Fargo Public Schools Maintenance Projects

ICON Job 24-060

Addendum 001

Date: 12/30/2024

Trollwood Performing Arts Site Plan - Enlarged

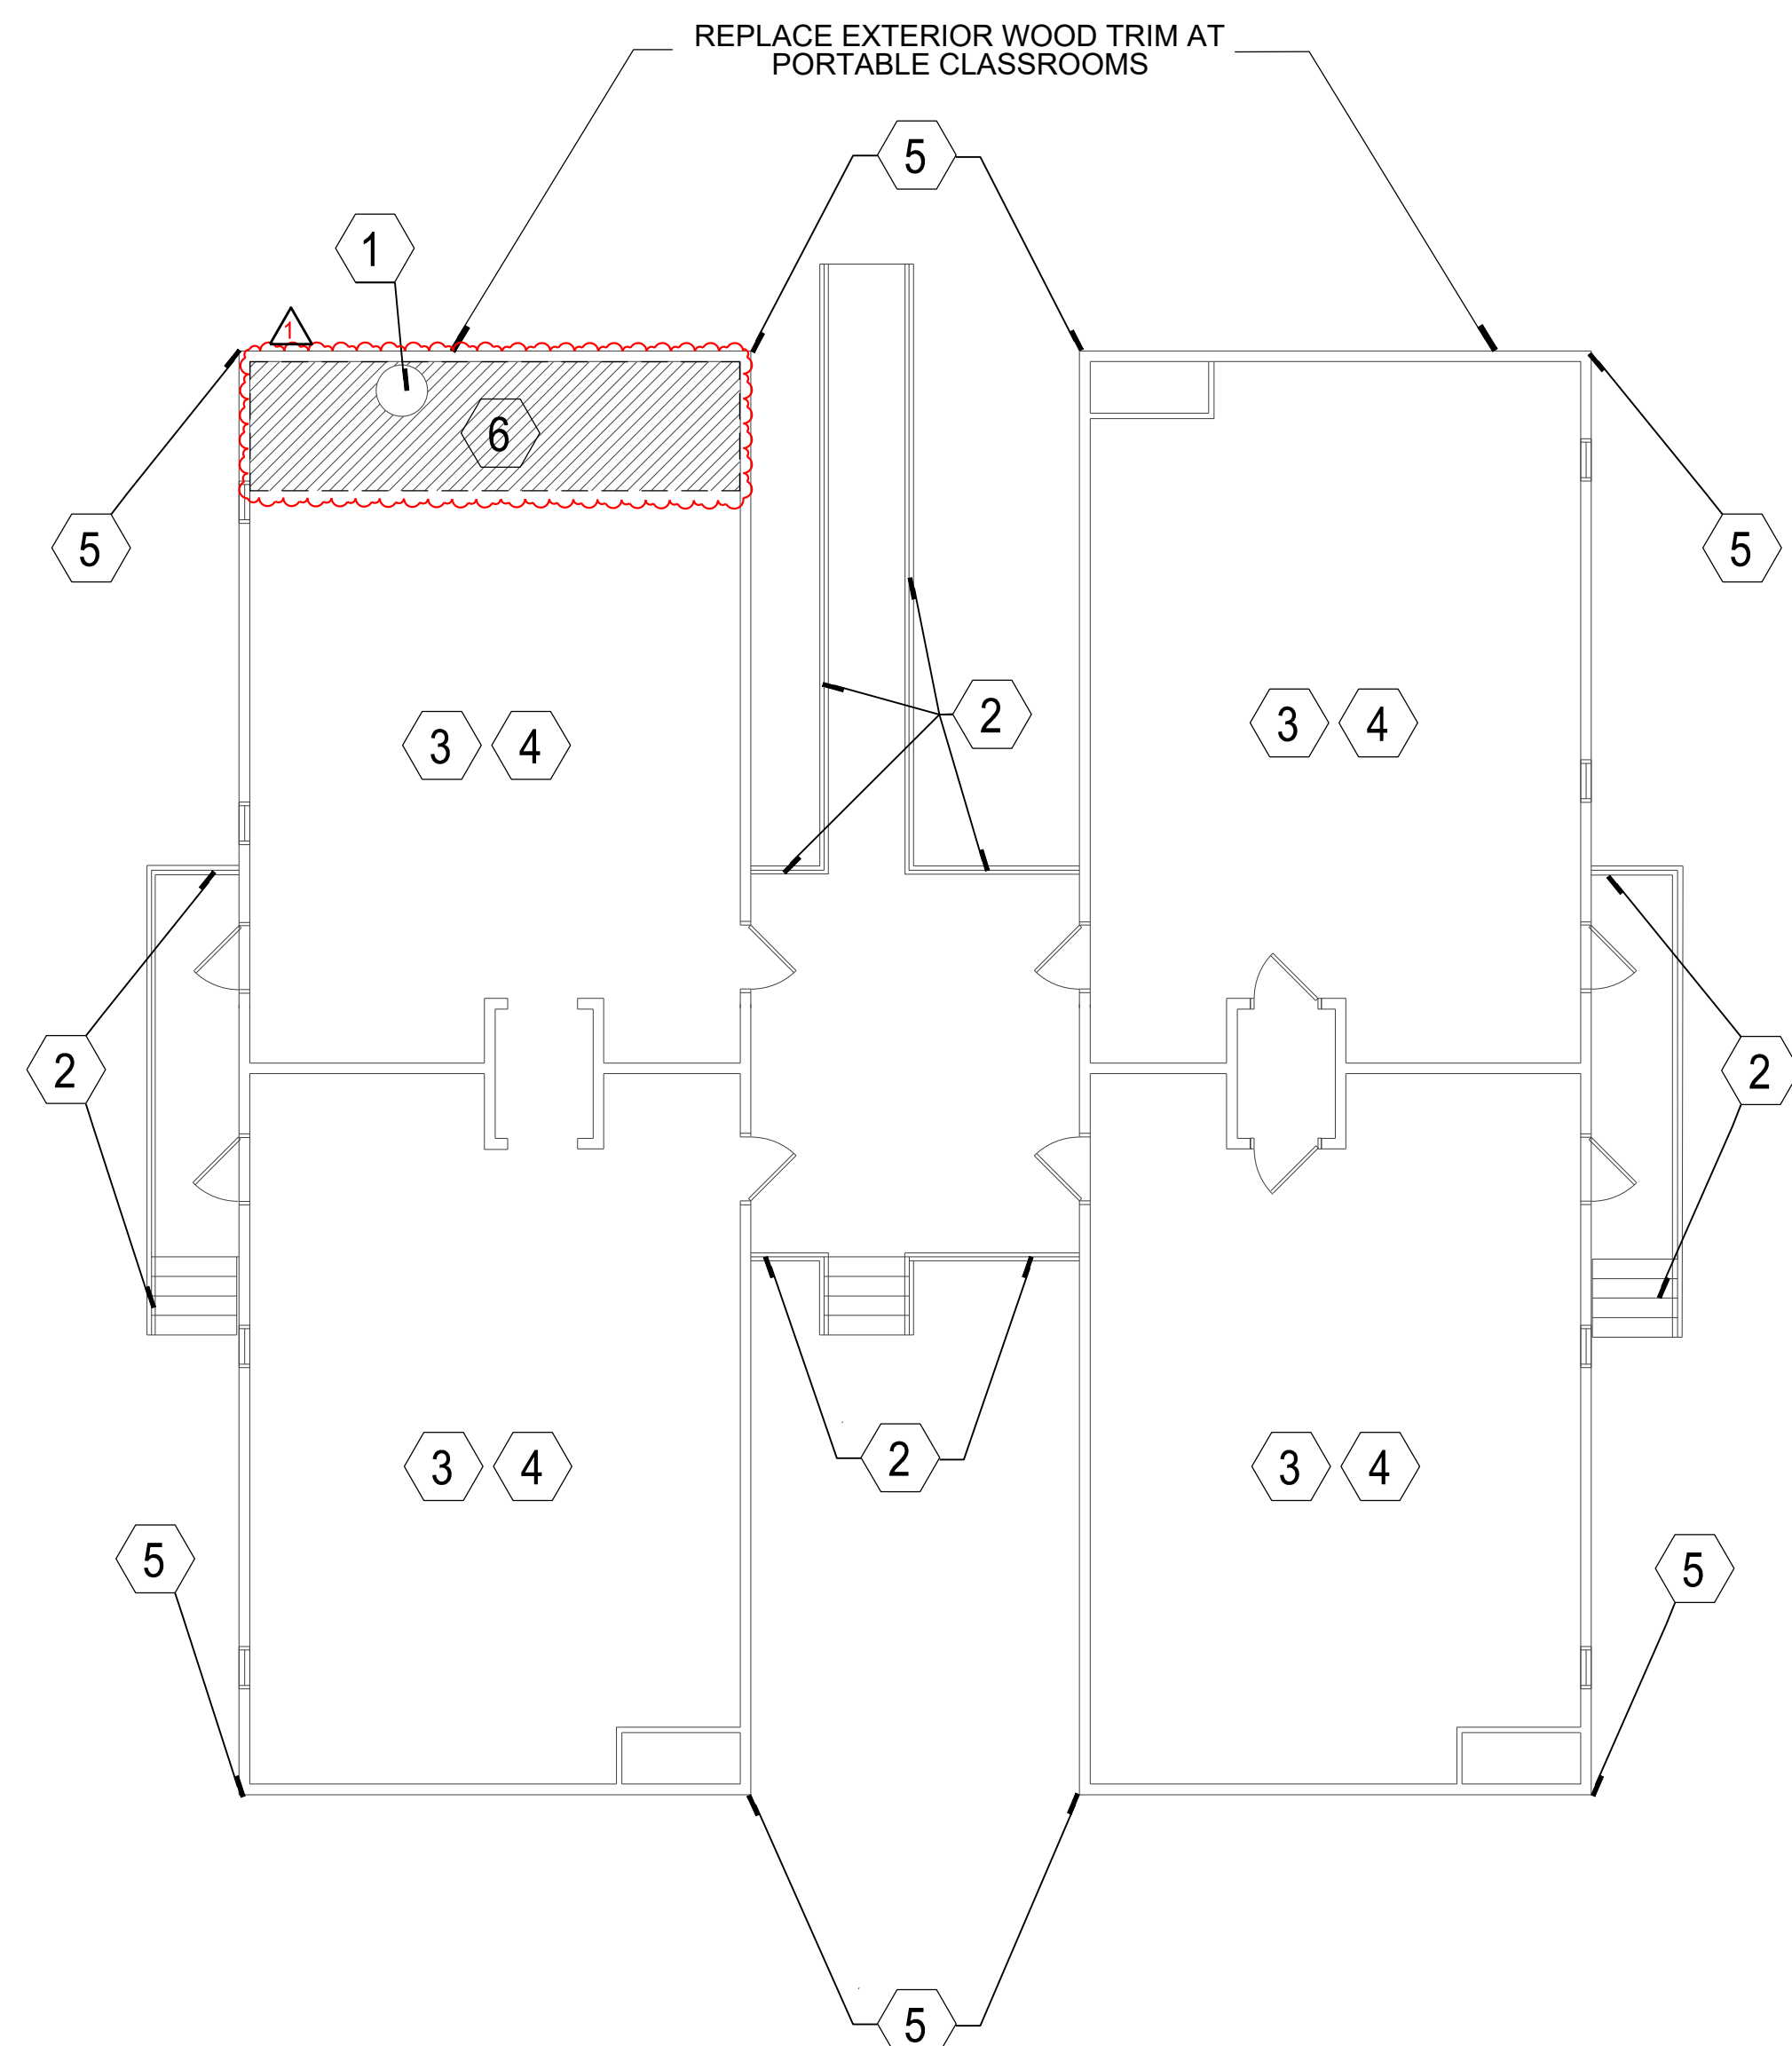
- 1) General Note 2 added.
- 2) Replace Vinyl Flooring Comment added to sheet.

Trollwood Performing Arts Portable Classroom Plans

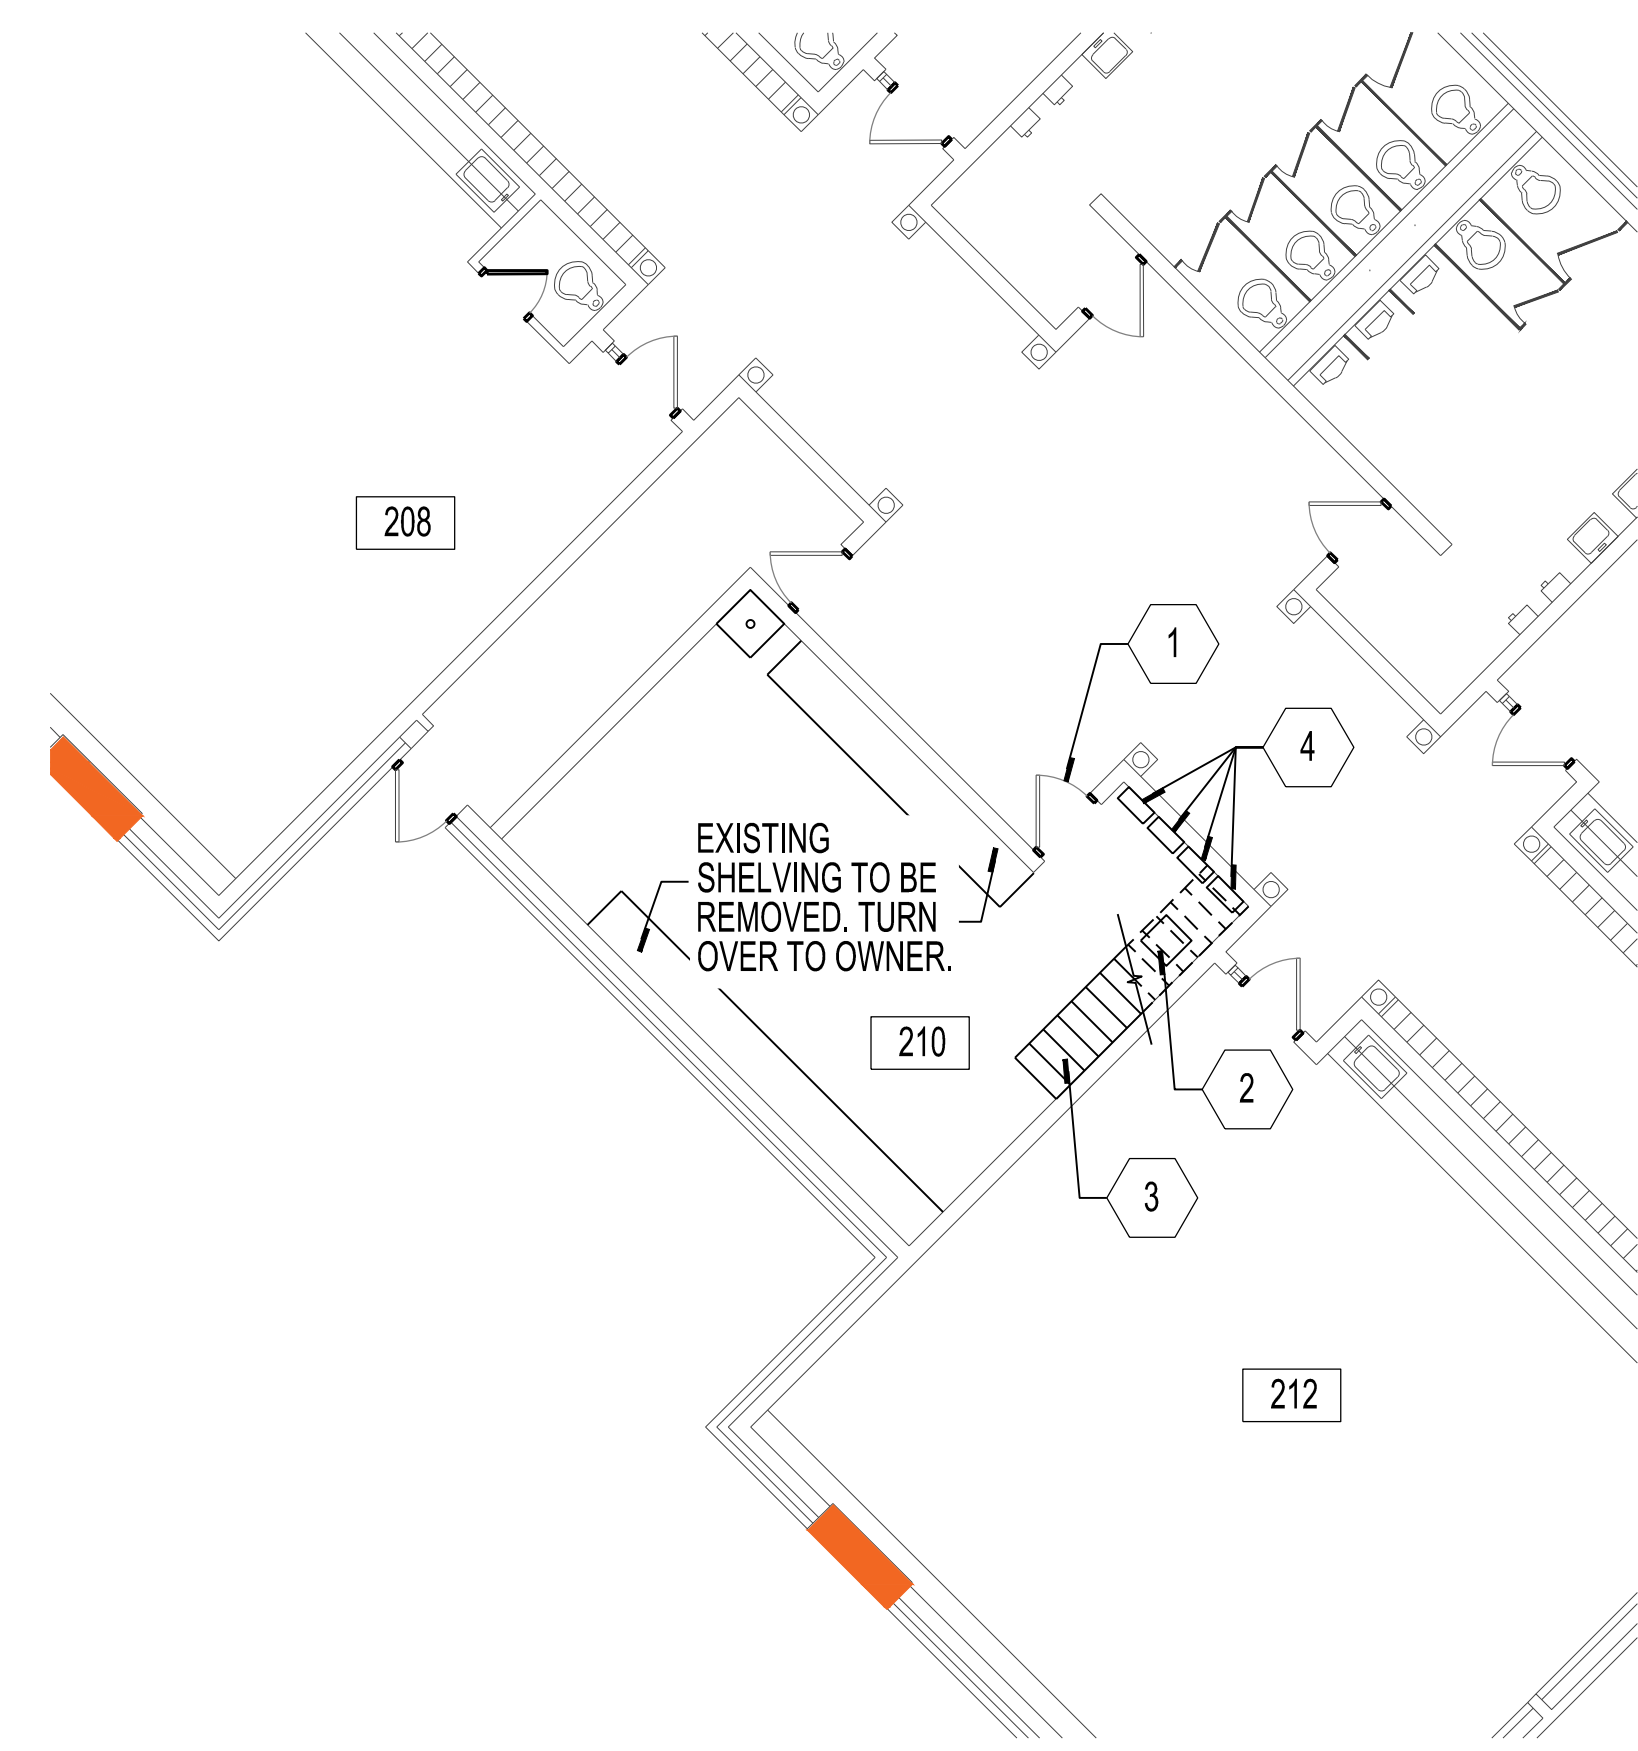
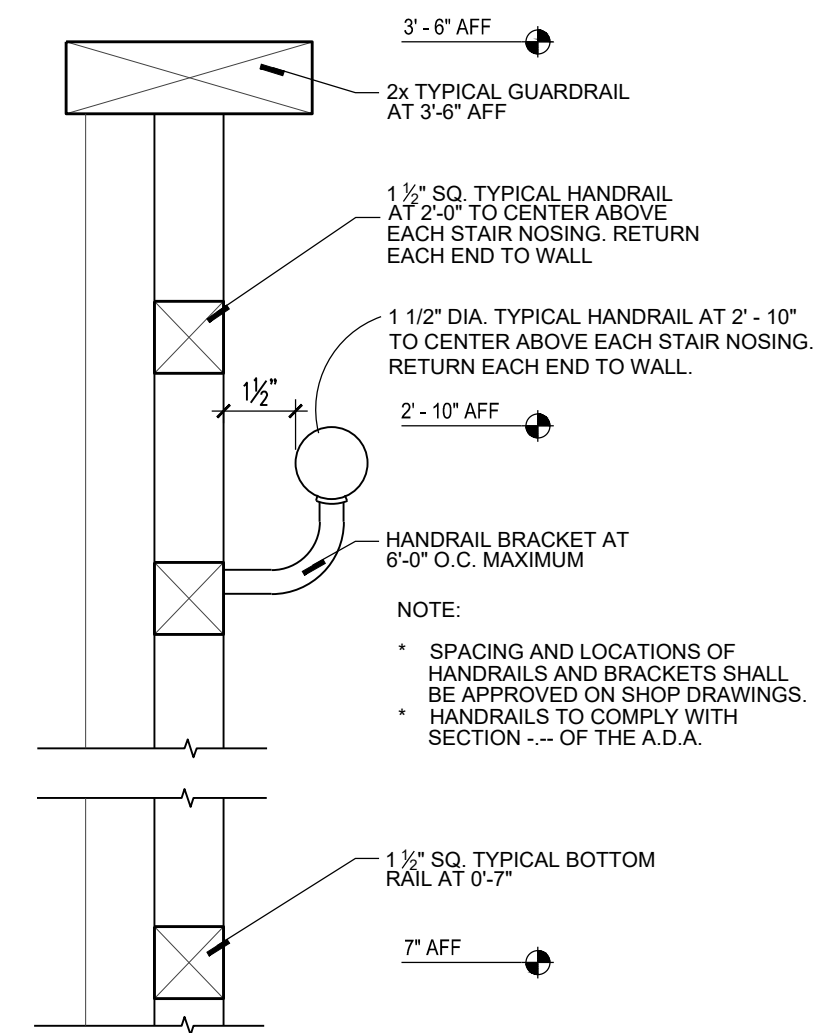
- 1) General Notes added.
- 2) Keynote 6 added.
- 3) Vinyl flooring replacement noted on floor plan.
